Case File Number: PLN15048, T1500023, ER15001

May 25, 2016

Location:	Mountain View Cemetery (Piedmont Avenue, near Pleasant Valley); 5000 Piedmont Avenue; APN: 048A700200302
Proposal:	Expand cemetery development in currently undeveloped portions of existing cemetery to accommodate future additional burial sites.
Applicant:	Mountain View Cemetery Association, Jeff Lindeman, (510) 658-2588.
Owner:	Mountain View Cemetery Association
Planning Permits Required:	Major Conditional Use Permit, Design Review, Tree Removal Permit, Creek Permit, compliance with CEQA.
General Plan:	Urban Park and Open Space
Zoning:	RD-1: Residential Low Density
Environmental Determination:	EIR
Historic Status:	“A1+” rating and API, OCHS
Service Delivery District:	2
City Council District:	1 -- Kalb
Action to be Taken:	Conduct preliminary design review
Finality of Decision:	NA
For further information:	Contact case planner Catherine Payne at 510-238-6168 or by e-mail at cpayne@oaklandnet.com

CITY OF OAKLAND PLANNING COMMISSION

PLOT 82, 98, AND PANHANDLE TREE IMPACT AND REMOVAL PLAN

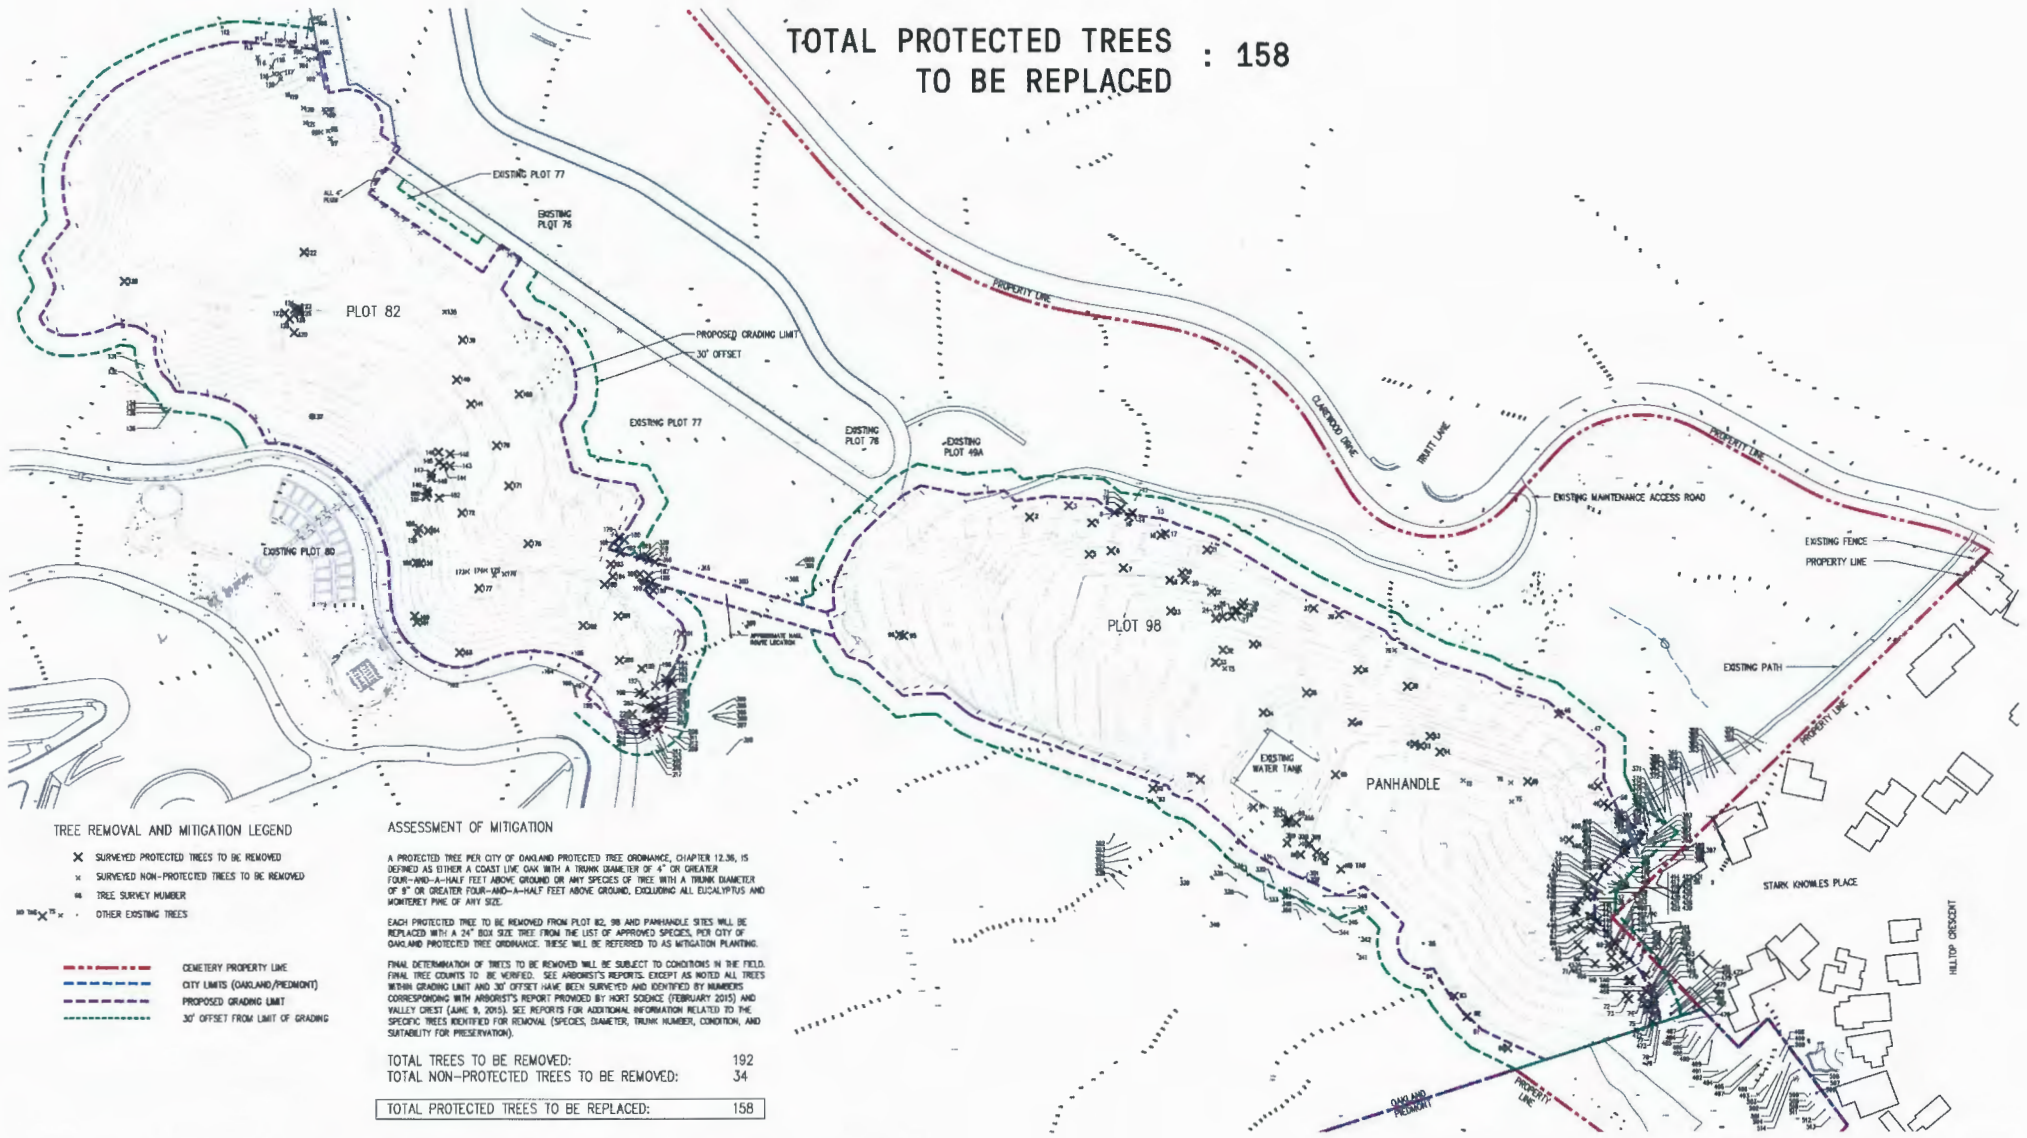
- Tree Removal: Trees: The proposed project would result in removal of as many as 192 on-site trees due to grading activities, including up to 166 "protected" trees, many of which are California Live Oak (*Quercus agrifolia*). In addition, there are 120 trees within 30 feet of the proposed grading areas that are potentially at risk due to construction activities, and would require tree protection measures to ensure that they are maintained in good health. These are trees that have been found to be healthy enough to merit preservation. The project also includes planting of 328 new trees (including one-to-one replacement trees, as well as decorative trees). The planting design includes trees appropriate to the formal, manicured appearance of other burial areas and roadways throughout the cemetery, as well as more naturalistic plantings of native trees along sloped areas surrounding the burial areas.

- Are there trees proposed for removal that are of particular interest and/or concern for the community and DRC?
 - Landscape Scheme: The landscape design creates three gently sloped, manicured lawn areas with pathways and tree plantings along the northeastern perimeter of the burial areas. Although there are three areas to be improved, they are all adjacent to one another and are designed to function as a series of interconnected spaces, similar to the original cemetery design. At this time, the applicant has provided conceptual plans that indicate the locations of features but do not yet include schematic information, such as wall heights, stair details, or specific materials. The purpose of this submittal is to solicit input from the public and DRC regarding how the conceptual plan should be developed into schematic design.

AREA 1: SECTION AT GRAND STAIR

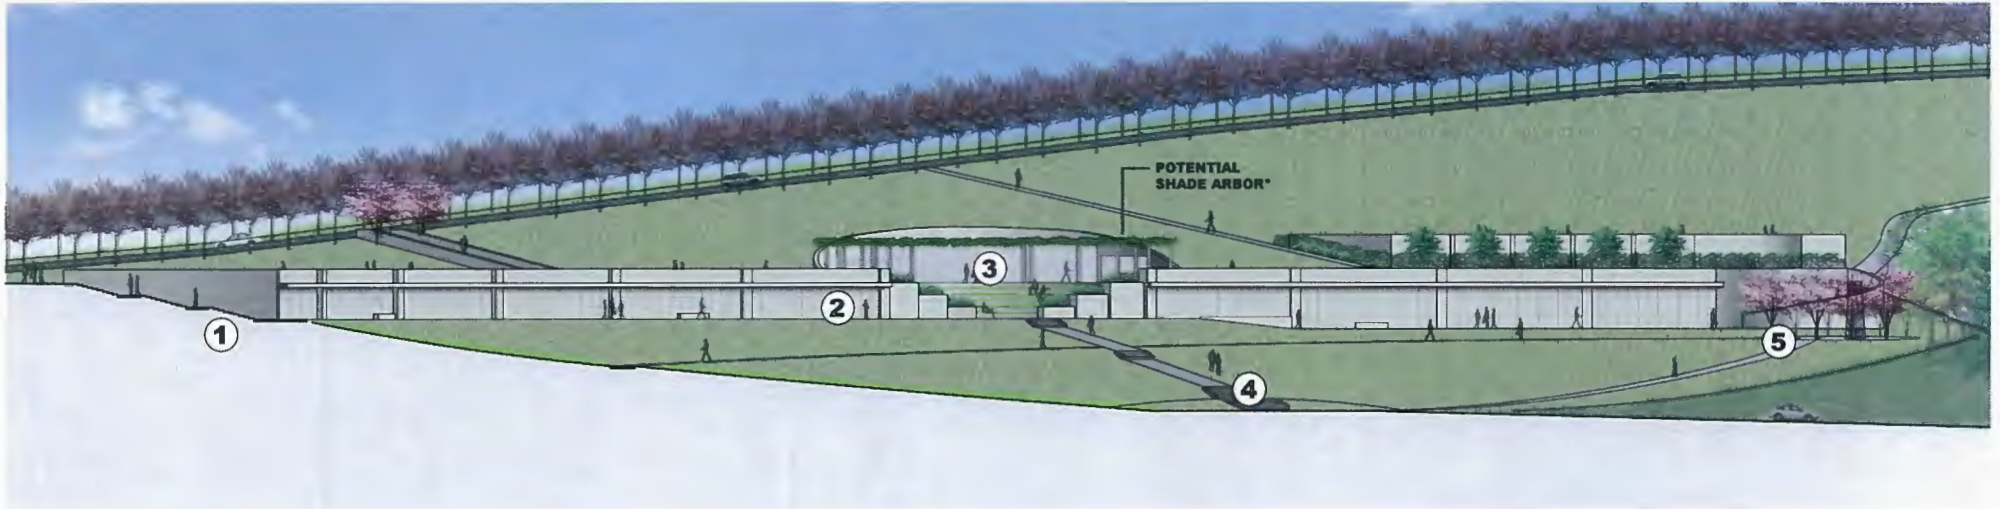
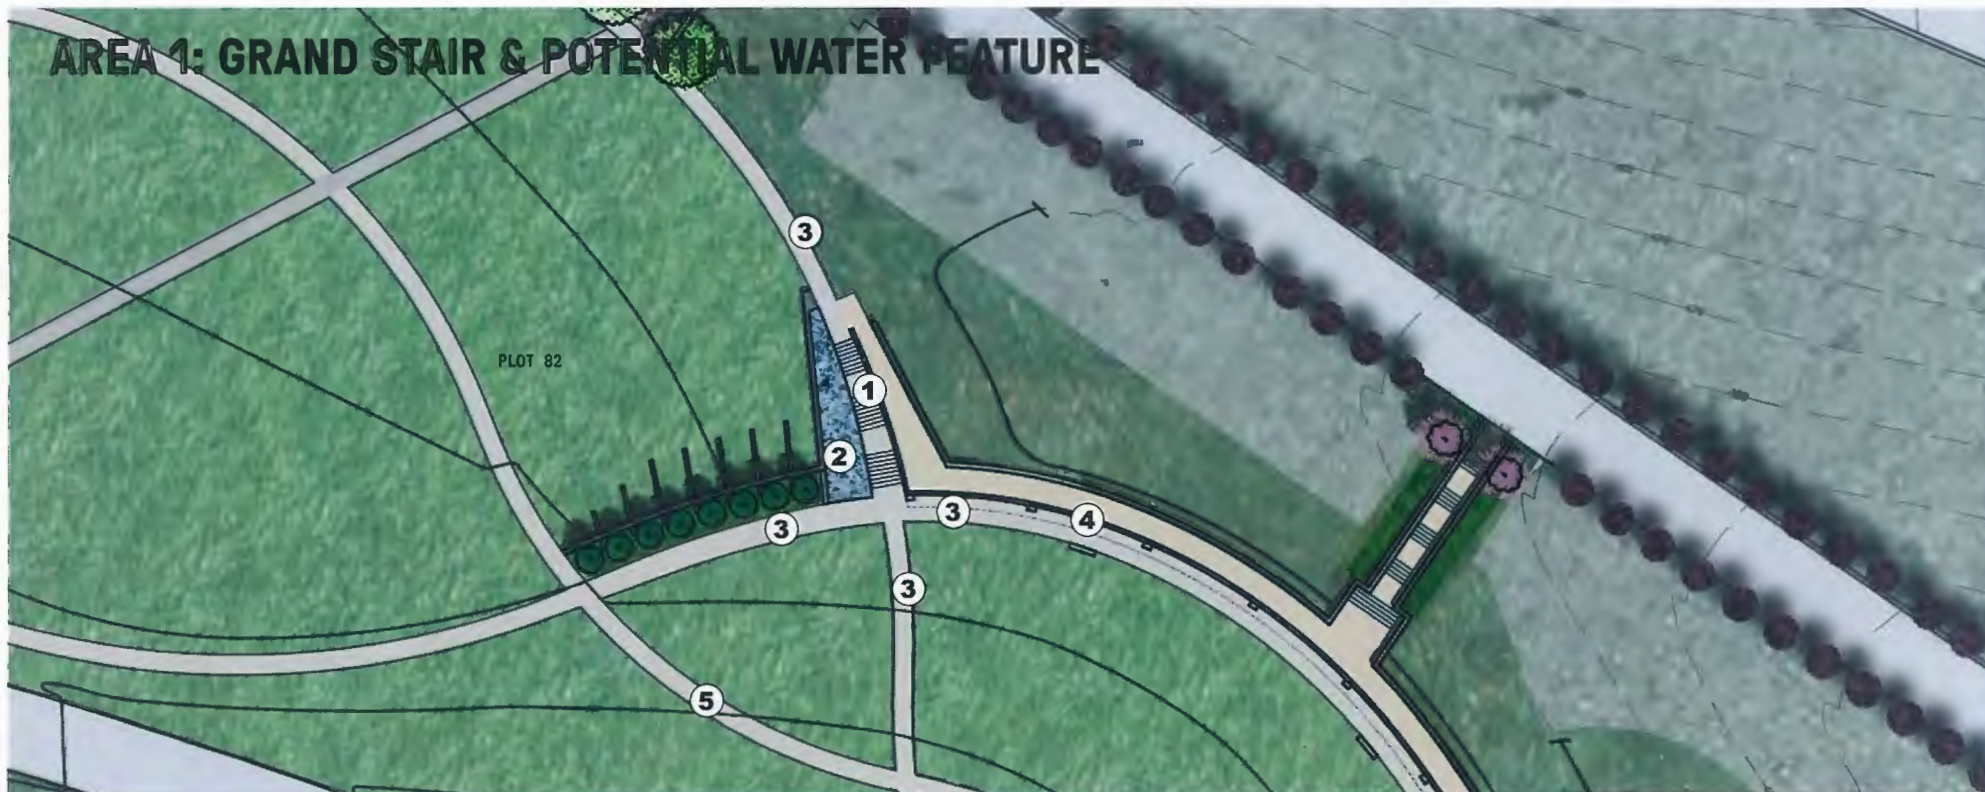
- The proposed plans include exterior stairs connecting the lower and upper levels of Plot 82 across the mausoleum wall. The stairs will be prominent features. Does the DRC have concerns or comments about the scale, design details or materials for the stairs?

AREA 2: SECTION AT AMPHITHEATER

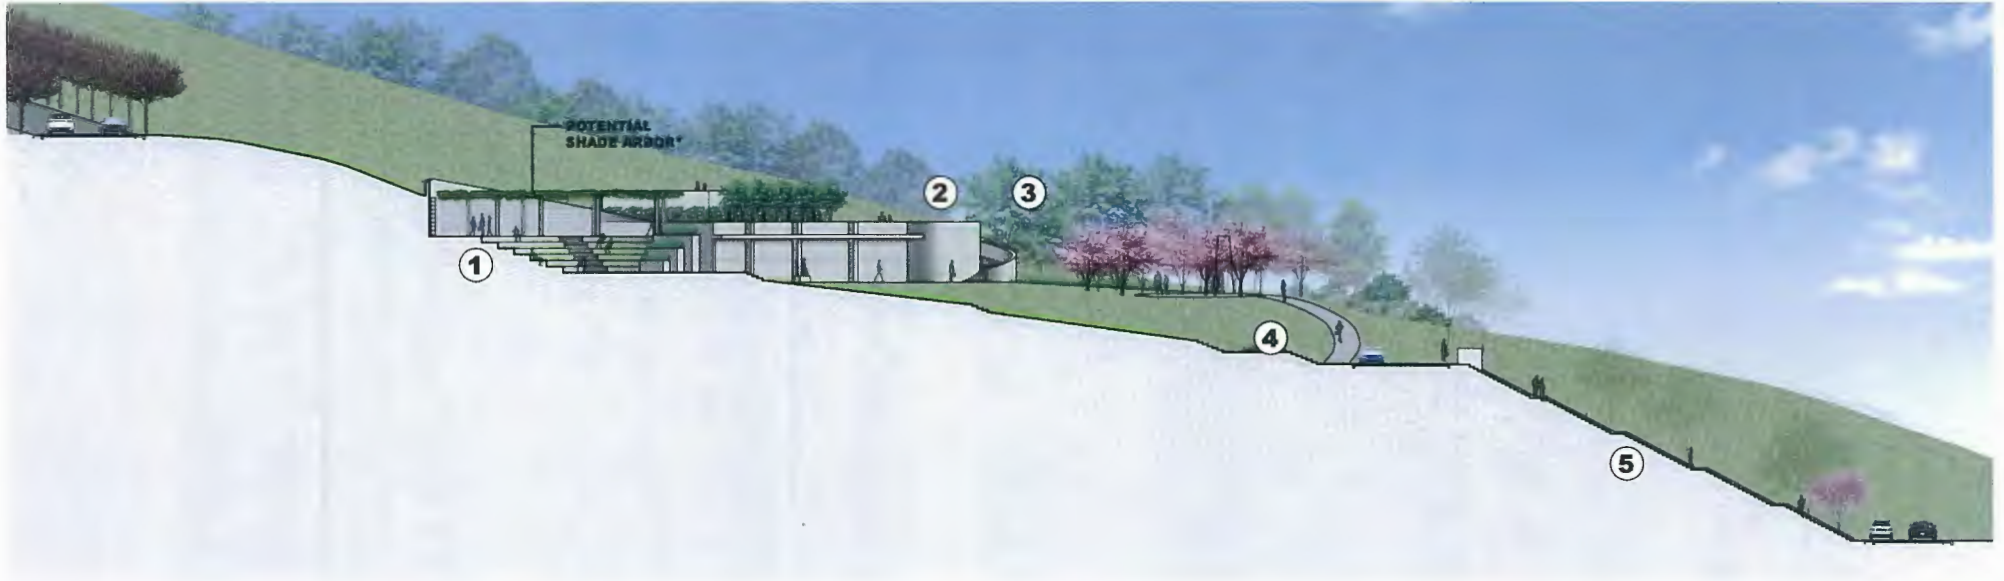
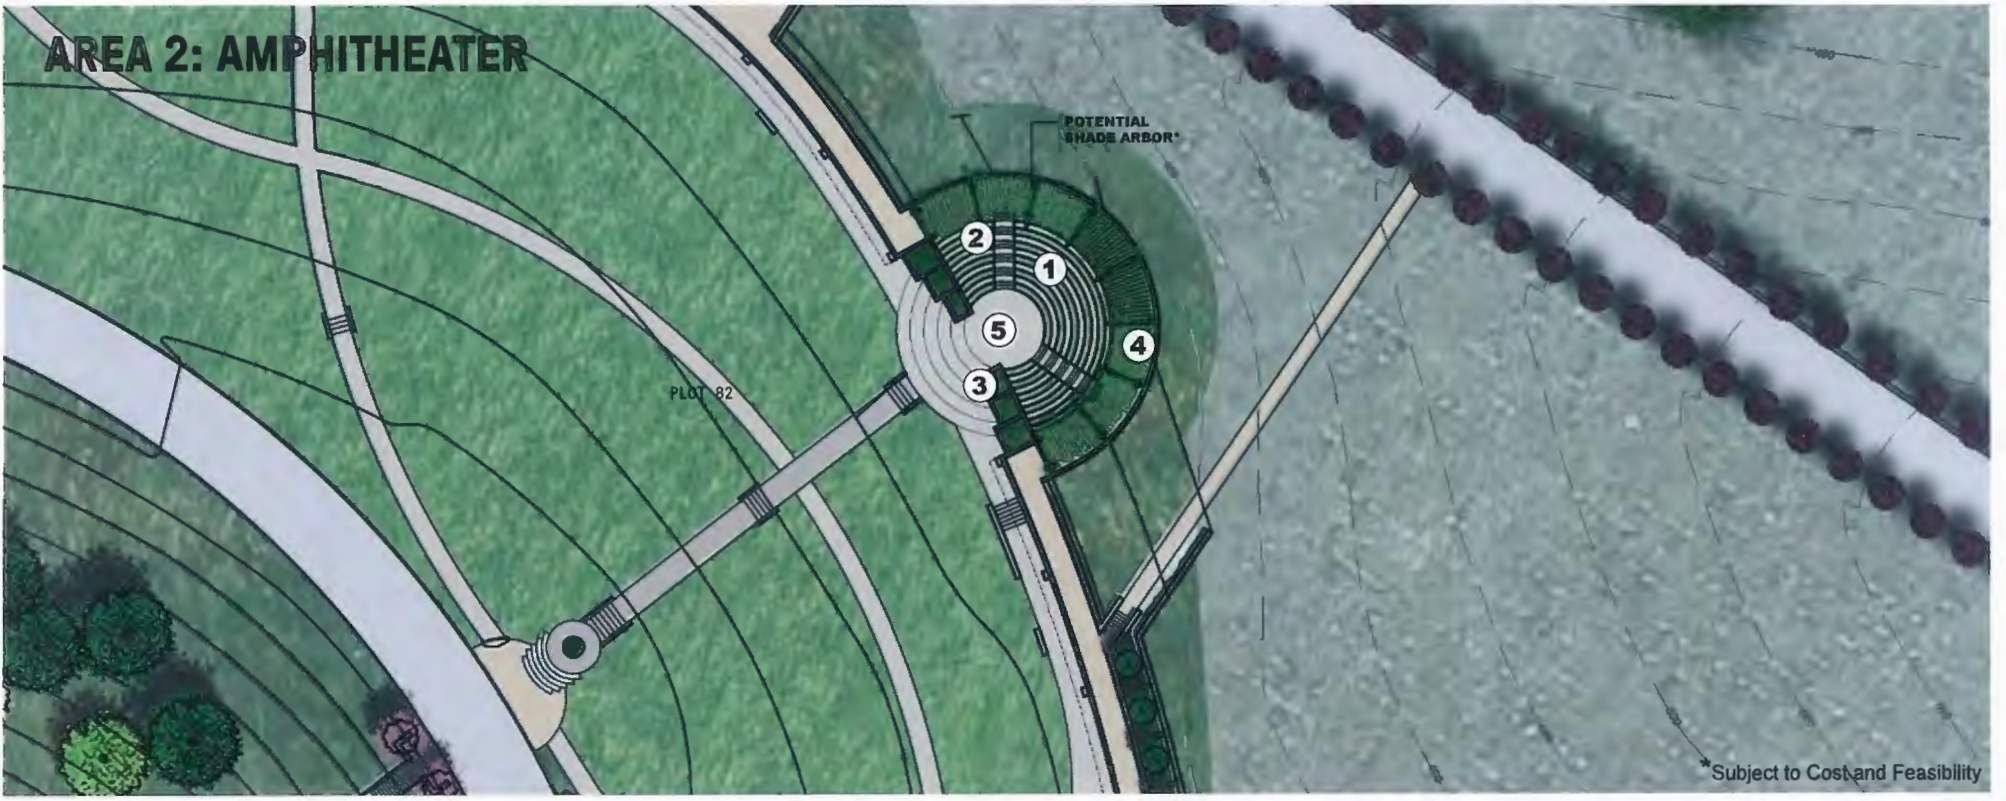
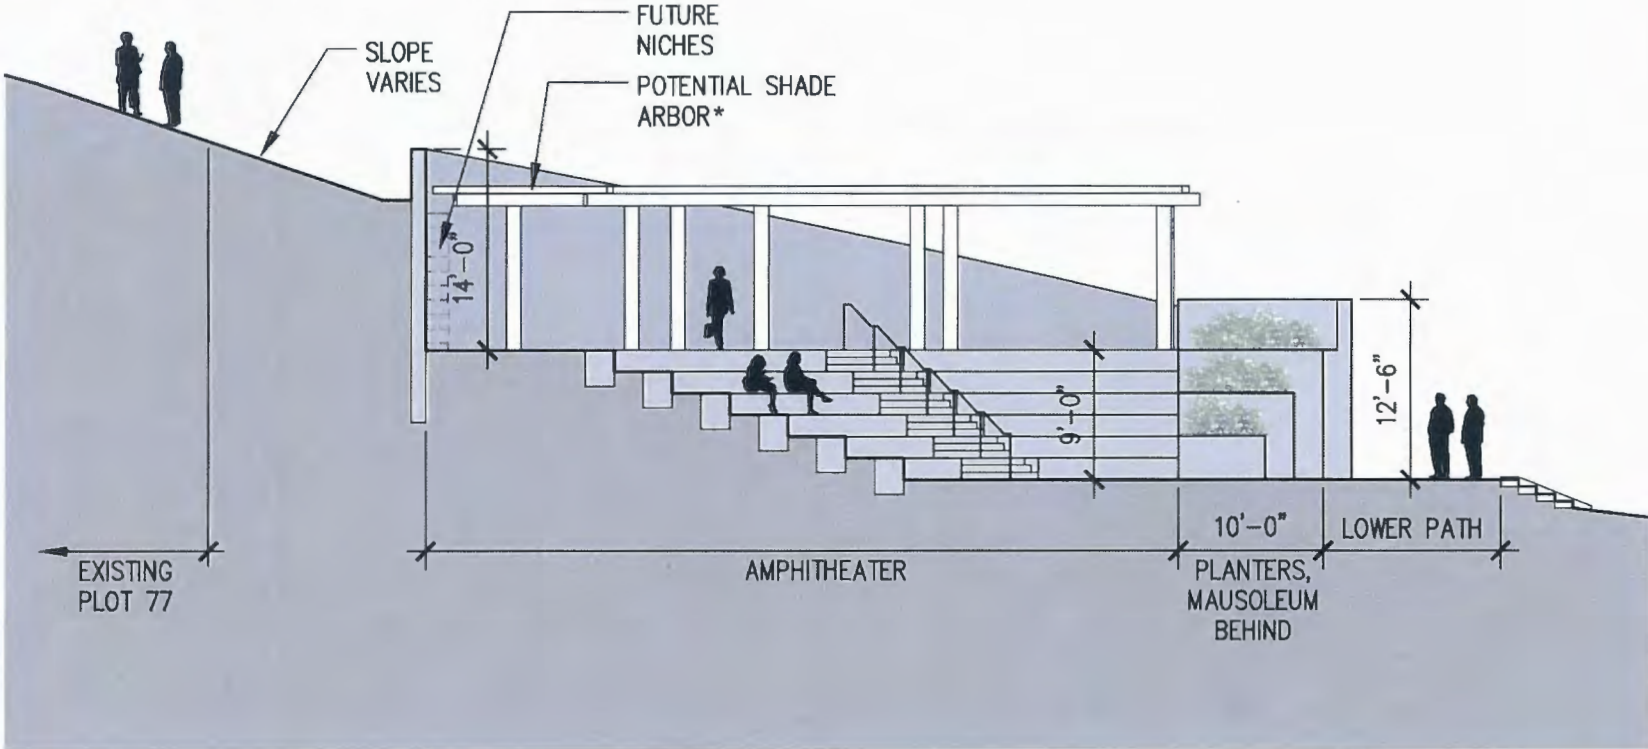
- The proposed amphitheater would provide relief for the mausoleum wall discussed above. Is the amphitheater an appropriate size to host services without overwhelming the space? Does the DRC have concerns or comments regarding the scale, design details or materials for this feature?
